To: Users of SFI Specs 2.7
From: SFI Foundation, Inc.
Subject: Spec 2.7E, Revision, effective December 3, 2021

The above referenced SFI Specs for Rear Engine Dragster Roll 7.50 Seconds and Slower have been revised, effective December 3, 2021. The revised version is designated as SFI Specs 2.7E and is immediately available from SFI for use by sanctioning bodies and chassis builders.

Section II.8:

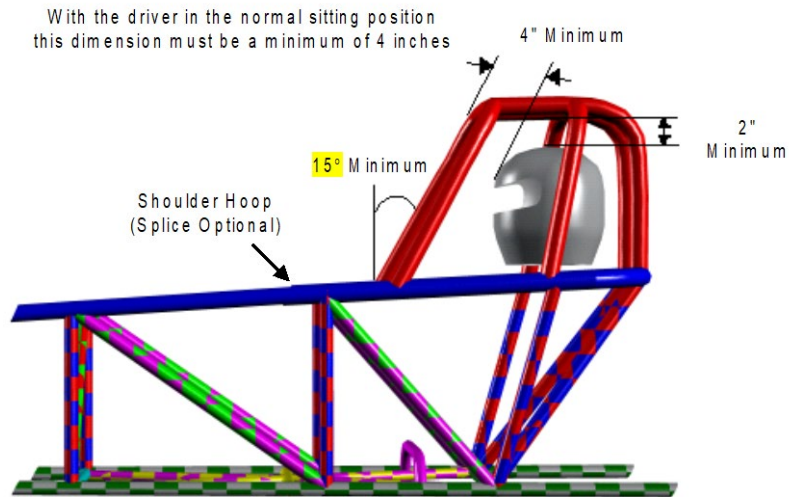
8. Diagonals and "K" members can be oriented in any direction, unless otherwise specified. Example: left to right, top to bottom, forward to rear, etc. Side bay and floor diagonals, X-members, and K-members must intersect within three tubing diameters of the intersection of the upright or cross member and the frame rail **within the same plane** (measured edge-to-edge, using tube diameter of the diagonal, X, or K.)
